The Corporation of the City of Kawartha Lakes

Committee of Adjustment Report – Brock

Report Number COA2019-055

The variance is requested at 788 Indian Point Road, geographic Township of Bexley (File D20-2019-038).

Site Plan Sketch - Proposed

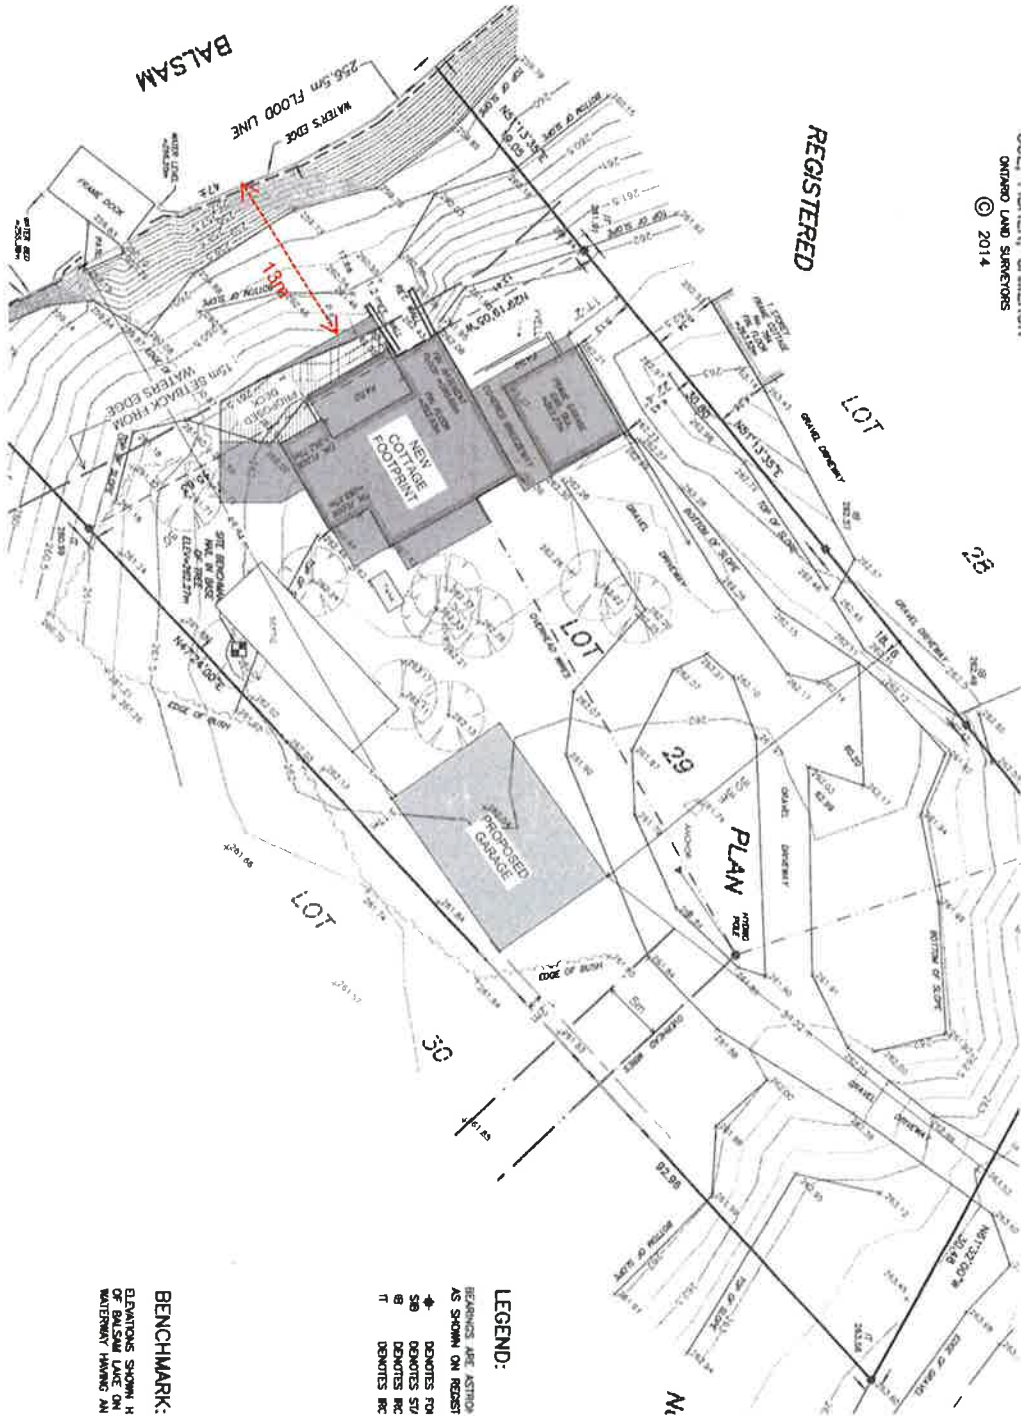
Regarding the request for the water setback relief, observation from site visit suggests that a compliant setback of 15 metres is achievable without hindering the functionality of the elevated deck. The primary function of a rear yard abutting a shoreline is to provide landscaped open amenity space for recreational purposes as well as to provide for the treatment of storm water runoff and an environmental buffer to the lake. The water setback buffer in the rear yard is proposed to reduce from approximately 17.6 metres (117.3%) to 13 metre (86.7%).

Section 3.1.4.1(c) provides that a deck which is at any point more than 1.2 metres above finished grade shall comply with the yard requirements applicable to a main dwelling. Staff observations during the site inspection found no evident physical constraint limiting the possibility of siting the proposed elevated deck for the dwelling in accordance with the water setback requirements.

A cursory observation from the site inspection suggests that an elevated deck extension of up to 1.8 metres from the furthest rear wall limits of the dwelling inside the rear yard should be appropriate to achieve the desired functionality of this structure whilst still maintaining compliance with the water setback provisions of the zoning by-law. This is a supportable alternative in staff opinion as the applicant had been advised from the very onset that an elevated deck extension that would contravene the water setback requirement is not supportable by staff.

- 2) **That** the depth of the elevated deck proposed within the rear yard area shall be located at a minimum water setback of 15 metres from the water's edge; and
